County of Fairfax, Virginia

STAFF REPORT ADDENDUM

APPLICATION RZ 2014-DR-022

Title of GDP:	General Development Plan, RZ 2014-DR-022, Brooks Property
Prepared By:	Christopher Consultants
Original and Revision Dates:	August 28, 2014, as revised through February 18, 2016

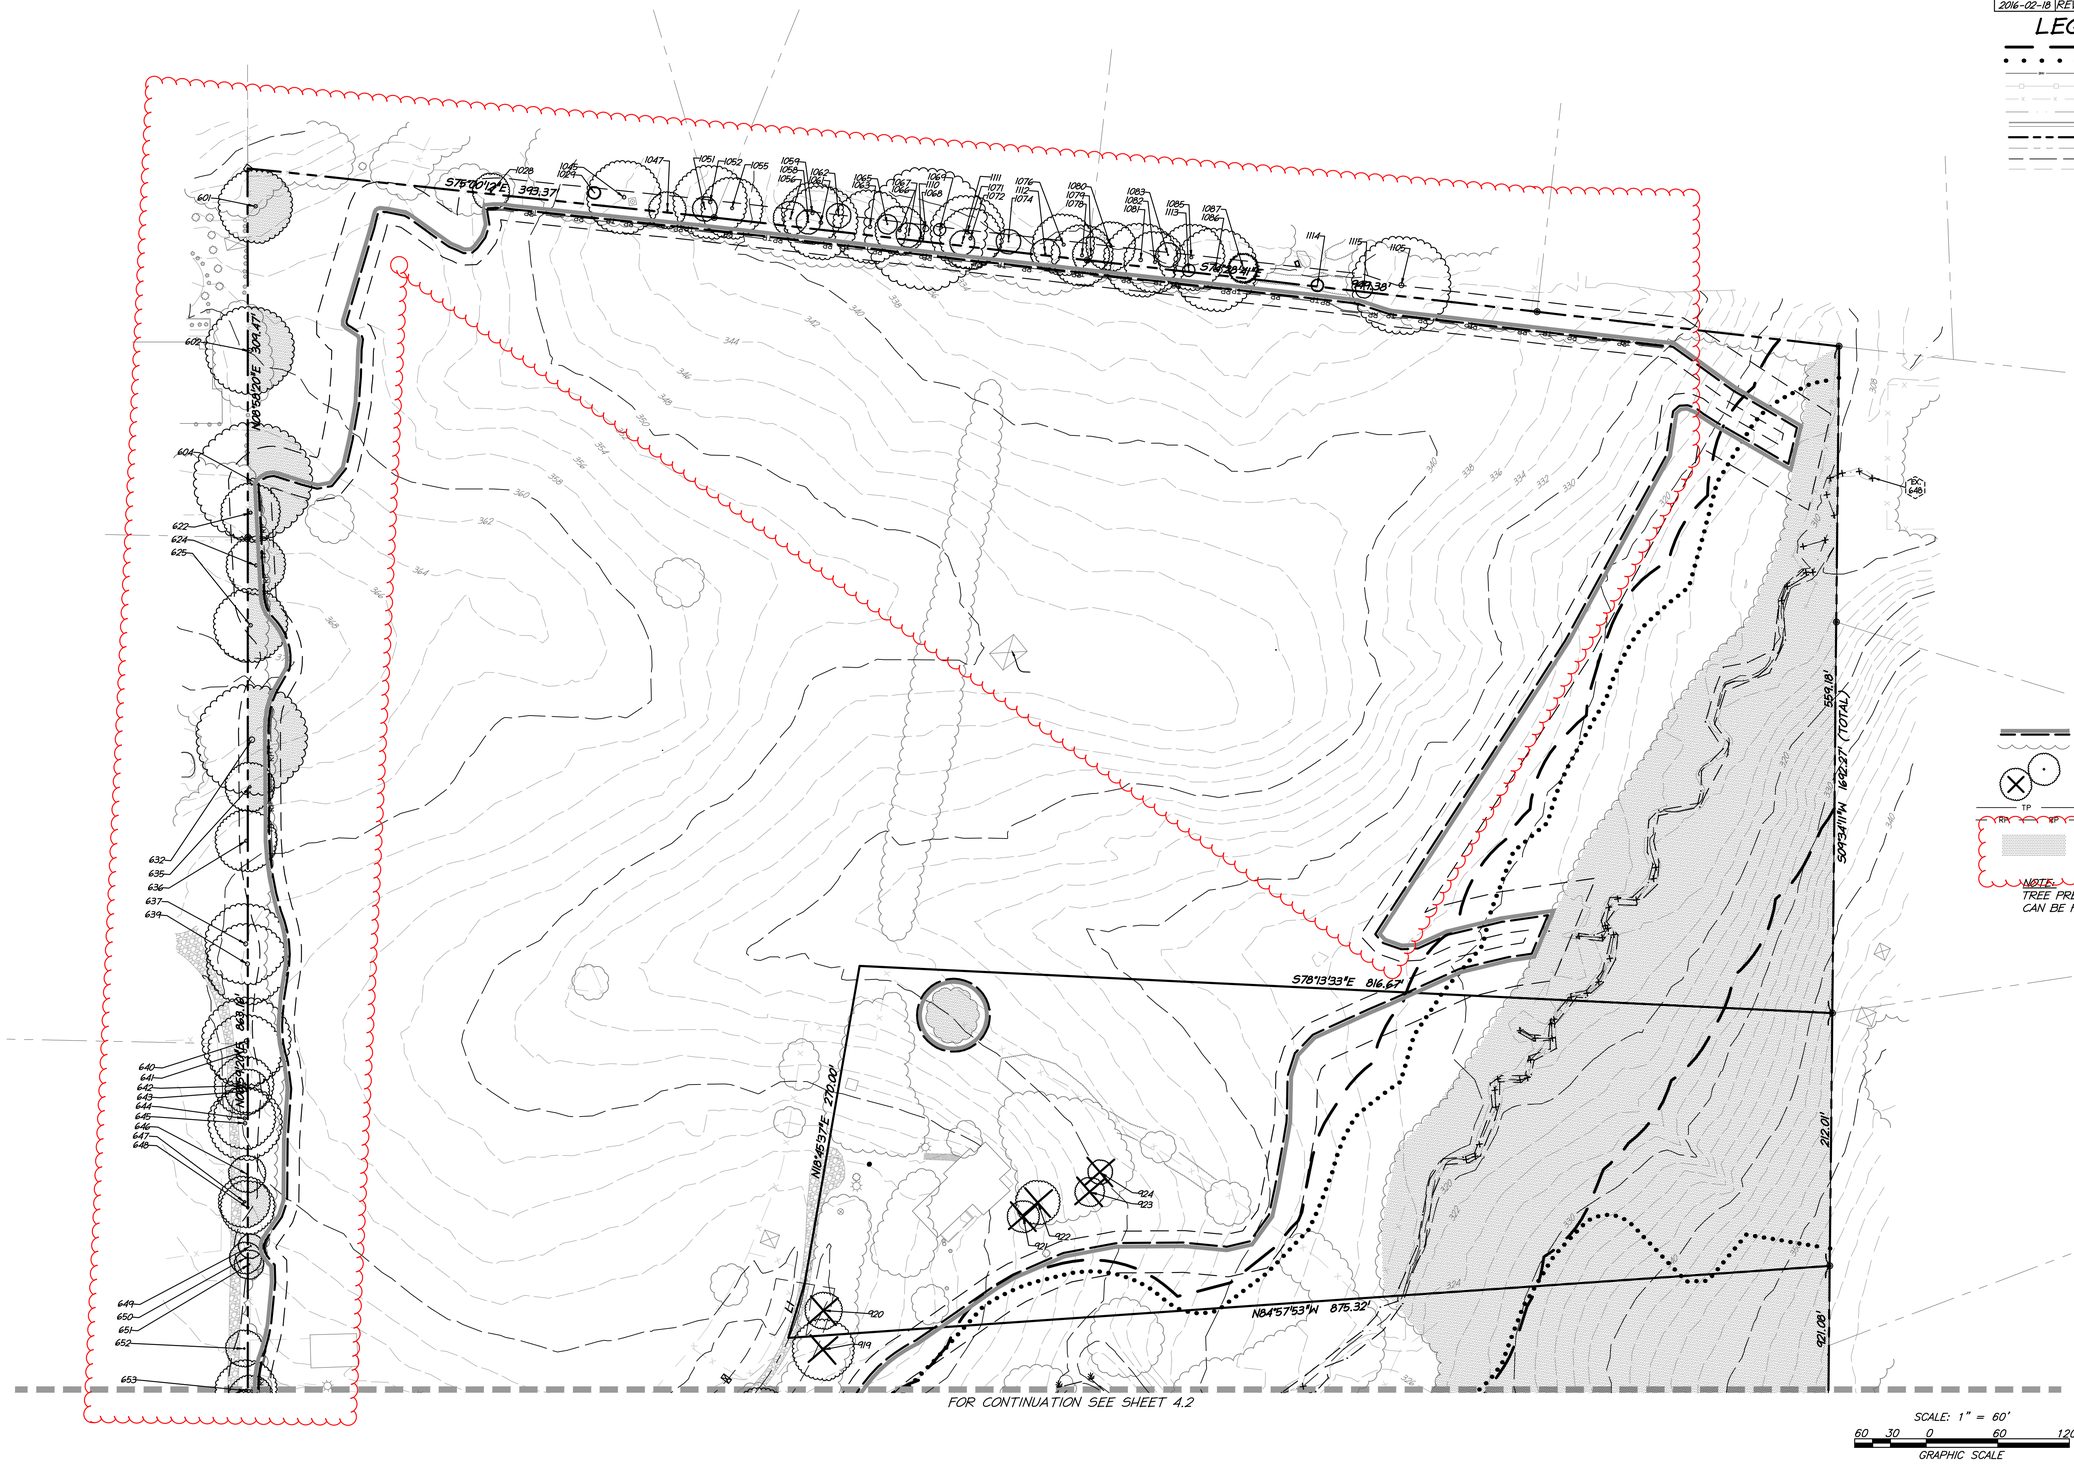
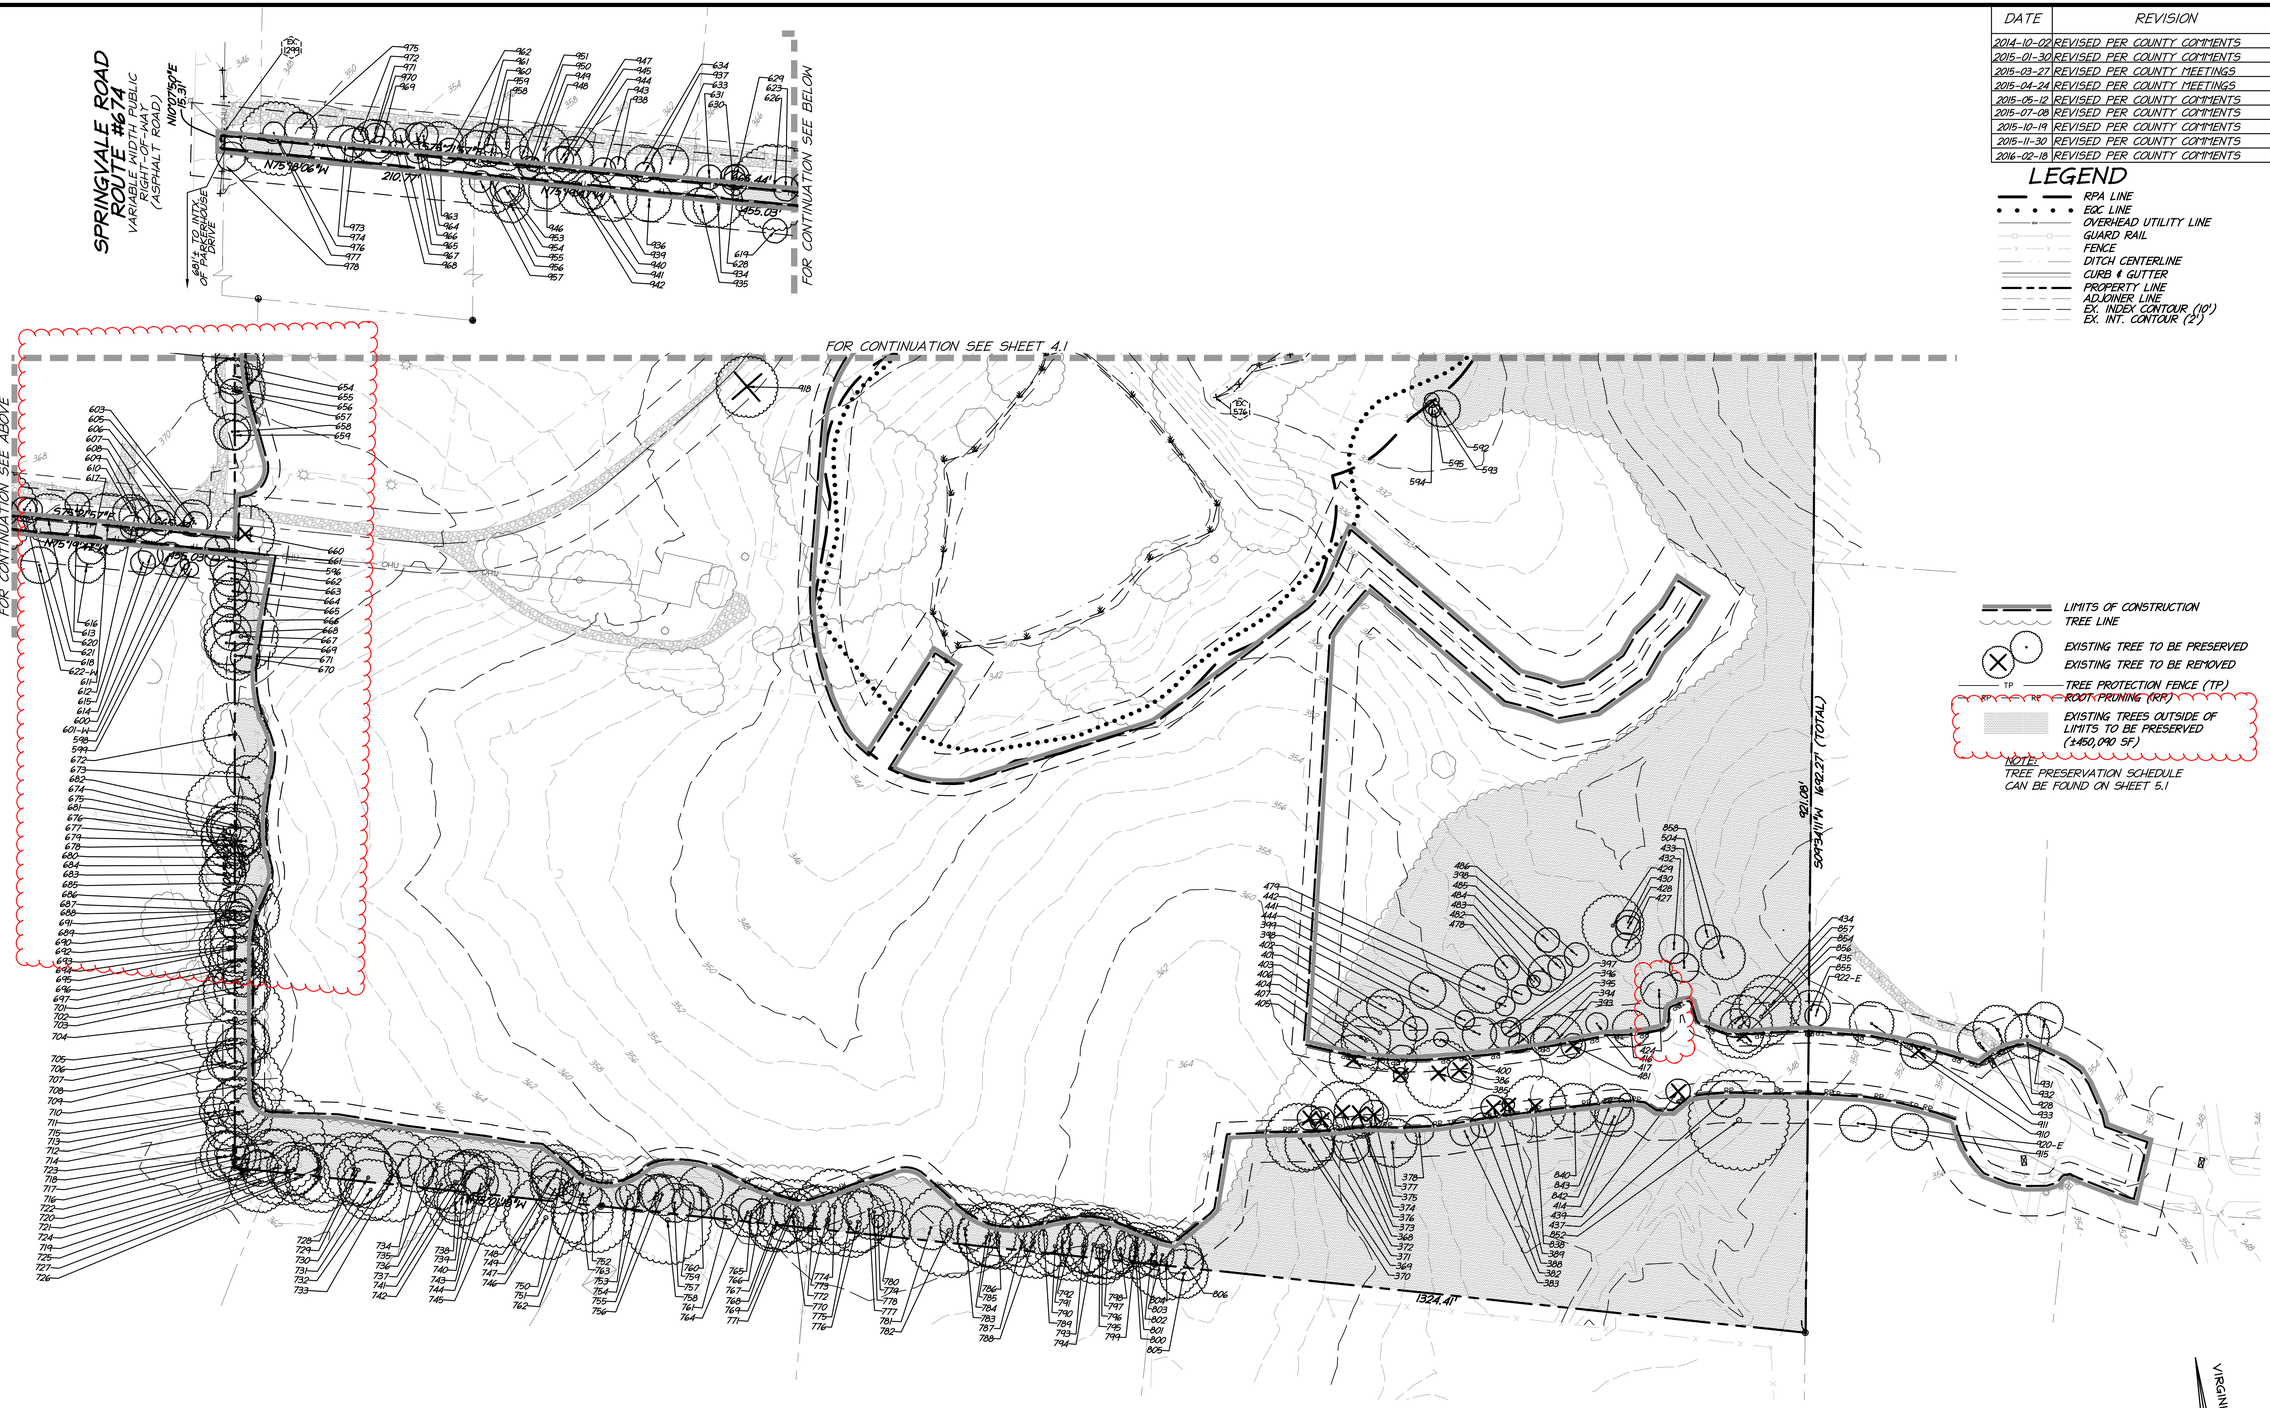
The key changes to the GDP occur along the northern boundary of the subject property. In accordance with Public Facilities Manual (PFM) requirements, Sheet 4.1 has been revised to show the off-site trees in the vicinity of the northern property line. The Tree Preservation Schedule on Sheet 5.1 has been amended to reflect inclusion of these trees.
